Wright Manufacturing, Inc.

Work Inst. Name: **71460069 to 71460098 Pulley Upgrade**

Inst. Number: **SVC-SWI-0028**

Revision: 01

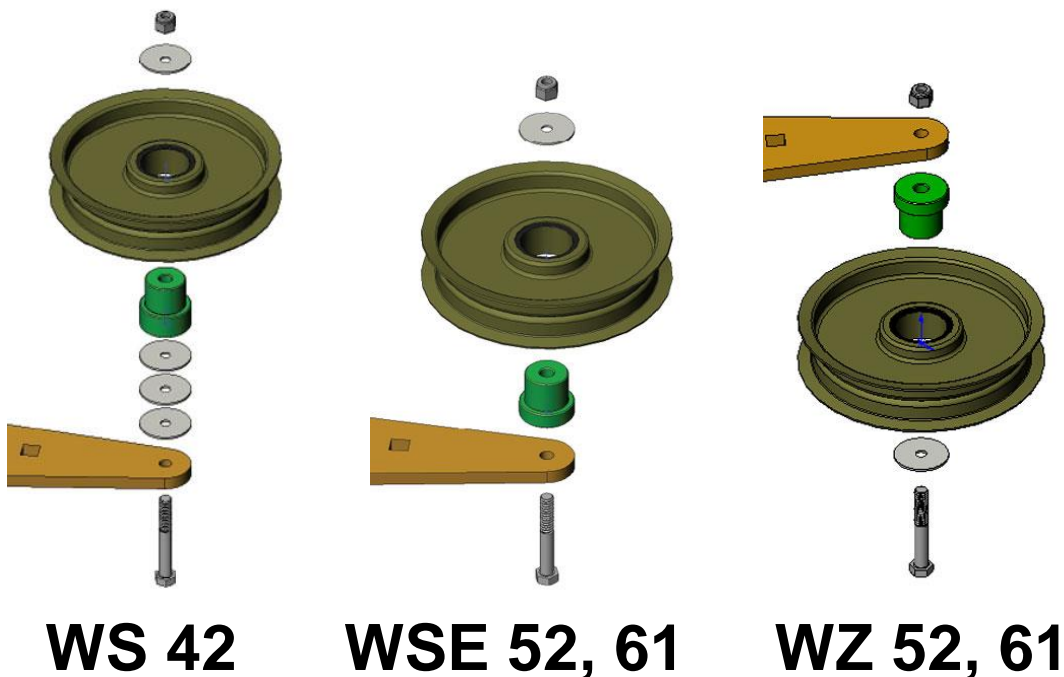
Items with an asterisk (*) are required for the initial upgrade to the 71460098 pulley.

1. For WSE and WZ mowers order kit # 71460106 or order parts individually
2. For WS42 order individual parts from diagram showing the WS 42 set up
3. Remove deck covers and blade belt
4. Remove idler arm
5. Remove idler pulley from arm
6. Install new pulley and hardware using appropriate diagram above and test

Note: Bolt lengths have changed; bolts listed above are for optimal fit
however original bolts will work.
